iFLY Novi JSP 18-49

Consideration at the request of SkyGroup investments, LLC for JSP 18-49 iFly Novi for Planning Commission's approval of the Preliminary Site Plan and Storm Water Management plan. The applicant is proposing a 6,713 square foot indoor recreational facility; popularly known as iFly that provides an indoor skydiving experience

PLANNING REVIEW

Review Date: October 1, 2018
Review Type: Preliminary Site Plan
Project Name: 18-49 iFly Novi
Plan Date: September 5, 2018
Prepared by: Sri Ravali Komaragiri, Planner
E-mail: skomaragiri@cityofnovi.org **Phone:** 248.735.5607

ORIGINAL ISSUE:
9/25/18
KHA PROJECT NO.
16005516
SHEET NUMBER
C1.0

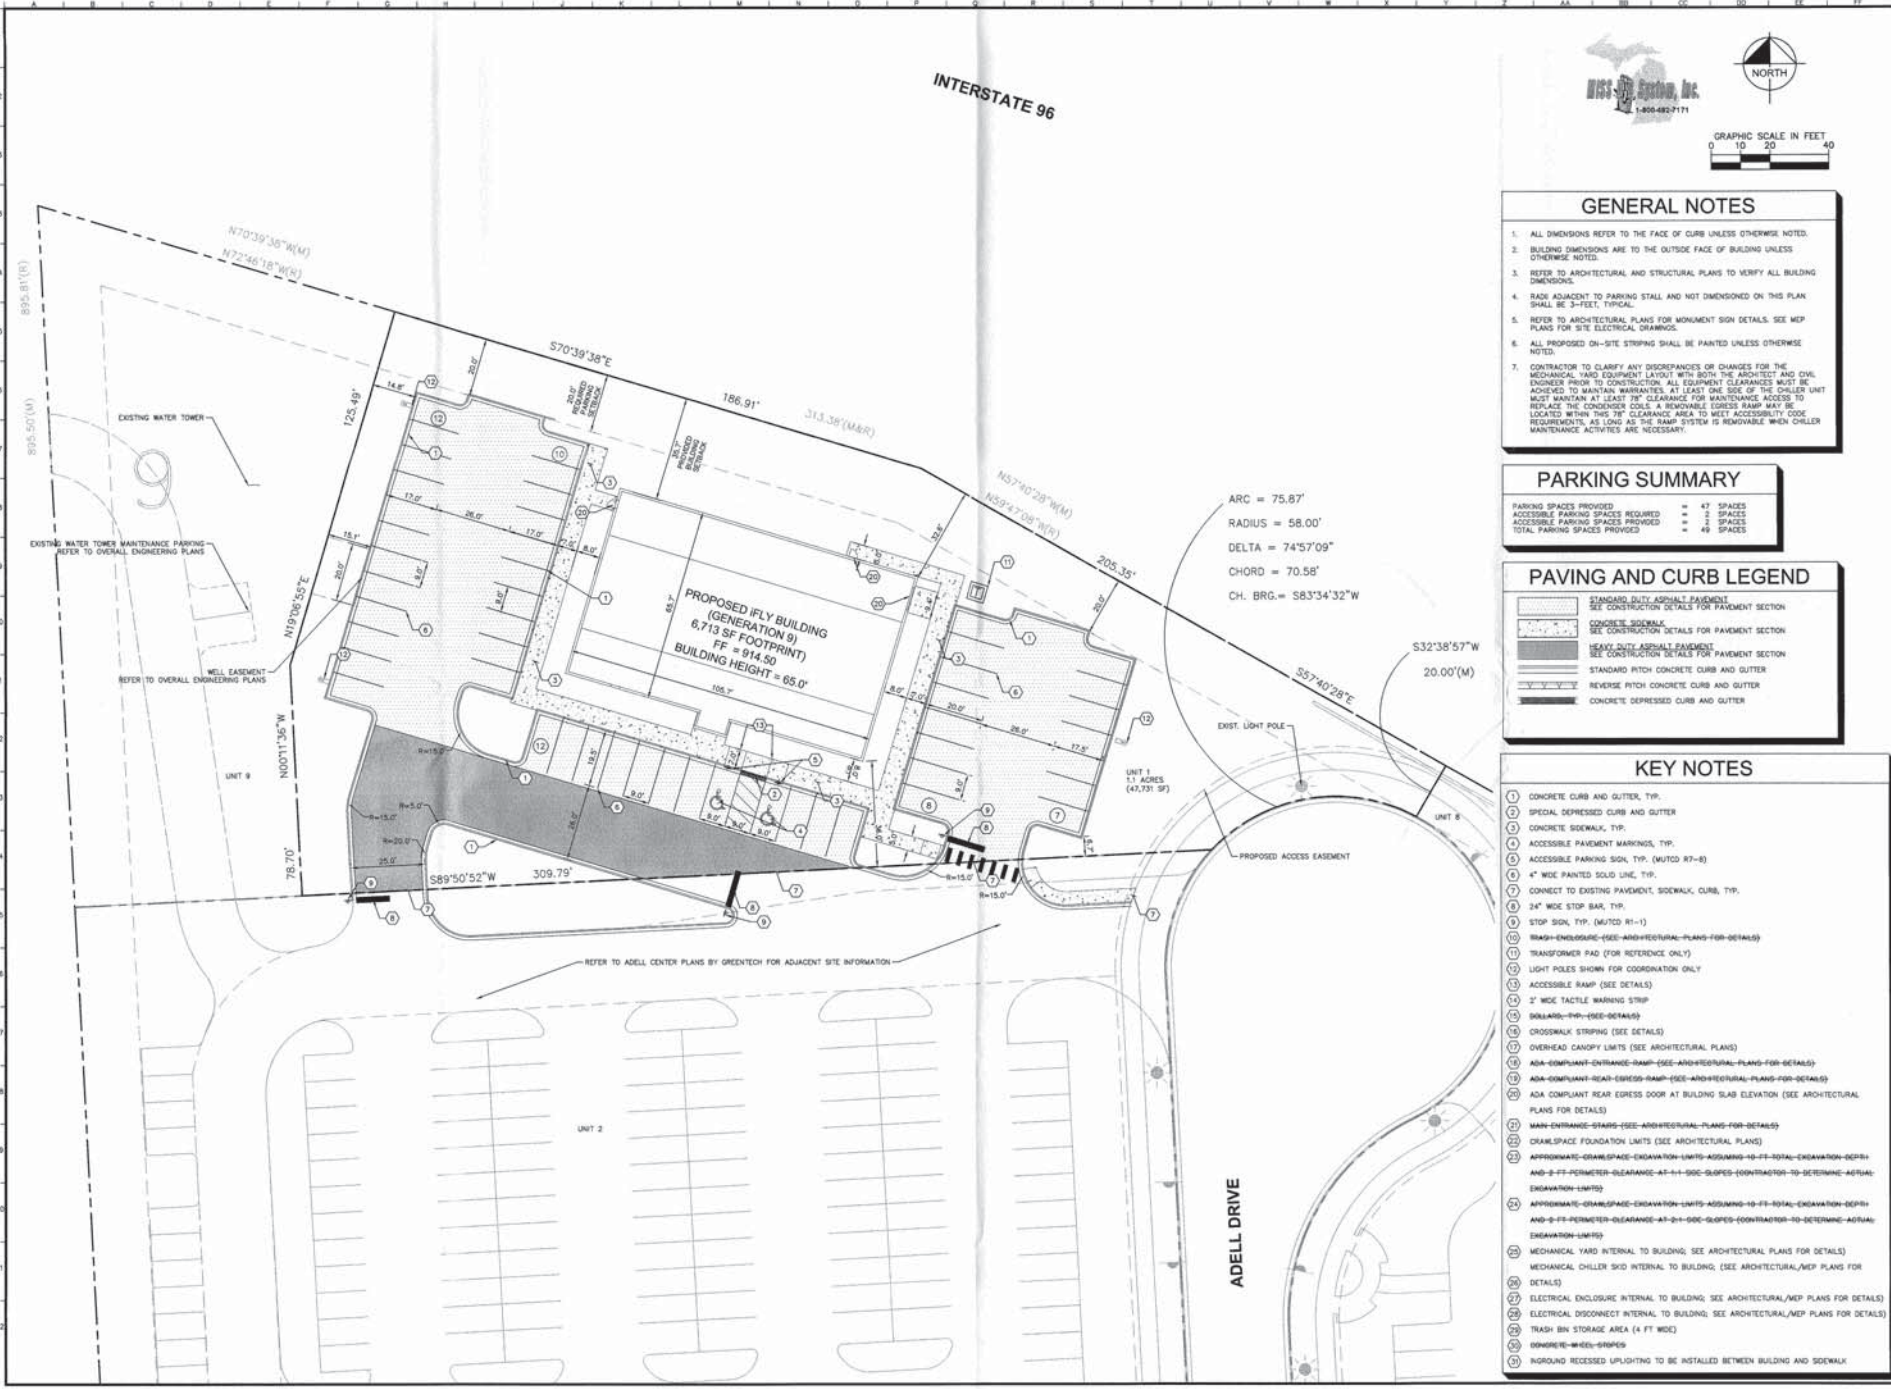
- a. Building setback along I-96 frontage. A minimum setback of 35 feet is allowed. 32.5 feet is proposed. **The building placement should be revised to maintain a minimum 35 feet setback from I-96 ROW.**

- b. A loading zone, dumpster and bike racks are not proposed. **The applicant should provide all as required. The applicant should provide supporting data to justify the proposed loading area square footages, to be reviewed and approved by Planning Commission at the time of Preliminary site plan approval;**

4. Drop-off Location: The applicant has indicated that customers sometimes come to the facility as a group, in a van or bus. **A drop-off location may be required given the nature of the indoor recreation proposed.** It can be located in any yard that is more feasible. It cannot conflict with parking spaces or circulation aisles. If it is located away from the building, appropriate sidewalks and crosswalks should be proposed to the entrance. **Please provide additional information about the frequency of drop-offs or buses accessing the site.**

5. Access to the site: The Preliminary Site Plan shows that two access points will be provided to the iFly building from the adjacent planned Planet Fitness Site to the south. The applicant has indicated on-site pavement for the iFly drives and parking areas, but no pavement is shown from the proposed Adell Drive. The Engineering letter indicates that all access and driveways to the site must be paved. The Draft PRO Agreement also indicates that the required secondary access drive for the entire Adell Center site, proposed to the south of the iFly site may be gravel, but only for secondary access purposes. **In the response letter, the applicant should explain how paved access will be provided to the site.** Any off-site easements anticipated must be executed prior to final approval of the plans.

BACK & SIDE ELEVATIONS

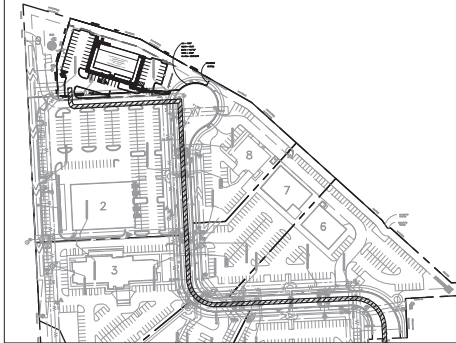
9. The applicant shall provide revised elevations addressing comments provided in Façade review letter dated August 14, 2018 for Planning Commission's review and consideration for approval of Section 9 waiver at the time of preliminary site plan review; **Façade is currently not recommending approval;**

Above listed deviations are based on signage information provided on August 08, 2018. As generation 9 prototype building is being developed, there are changes to building elevation and signage. The applicant has provided revised signage information on October 3, 2018 via e-mail. Staff did not complete the review of revised signage. However, it appears that the revised signs on side elevations are larger than 153 square feet allowed under draft PRO agreement. Further discussion is warranted between the staff and the applicant to address the revised sign sizes. As noted, above notes deviation are maximum amount authorized. Revisions are subject to Planning Commission's approval.
